DATE: March 17, 2011 TO: Distributors, Dealers, and Installers of Xantrex North American and Korean Single Phase GT Series Grid Tie Inverters SUBJECT: North American and Korean Single Phase GT Series Grid Tie Inverter Recall – Change To Field Repair Kit

DEALER / INSTALLER UPDATE

Product Identification

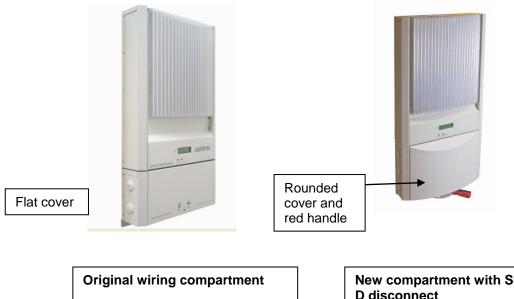
Flat cover

All affected models with 7- or 8digit part numbers.

Examples : 864-xxxx X-864-xxxx

New compartment with Square-D disconnect

Rounded cover and red handle

5 affected models with part numbers ending in -02

864-1001-02 864-1006-02 864-1008-02 864-1009-02 864-1032-02

Order bracket kit 864-9004

Order bracket kit 864-9005
